REQUEST FOR DIRECTOR'S REVIEW OF IMPACT FEE

Project Name: Secure It Self Storage – Cooper Point

Project Description: Mini Storage Warehouse, 126,000 sq ft, 844 units

ATTACHMENT TO REQUEST FOR DIRECTOR'S REVIEW OF IMPACT FEE

Mini-Warehouse (151)

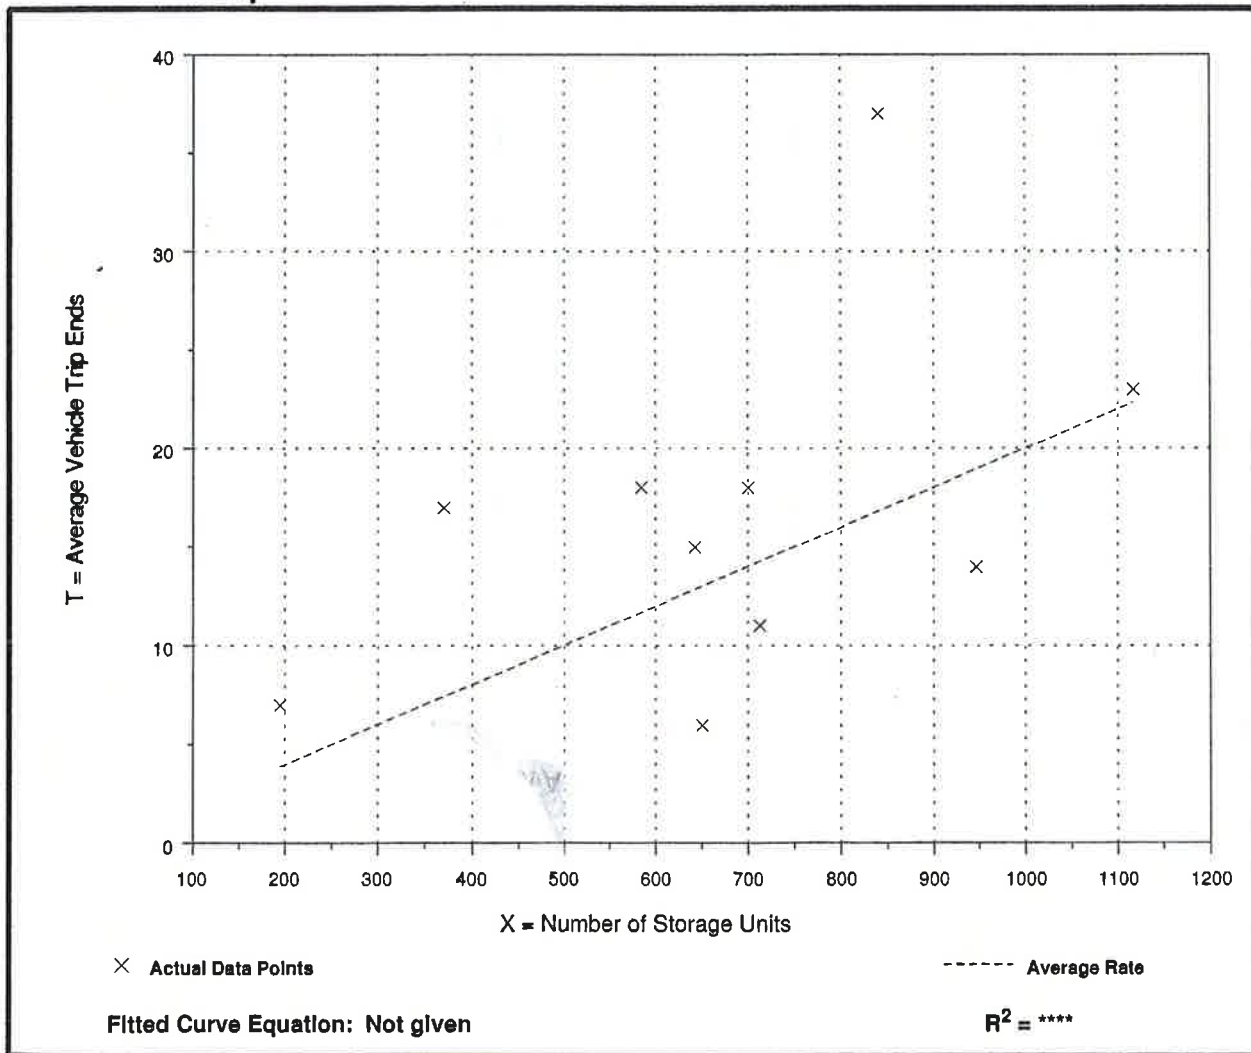
Page 10 table 3 calls out a rate of 0.26 PM Trips Per Unit
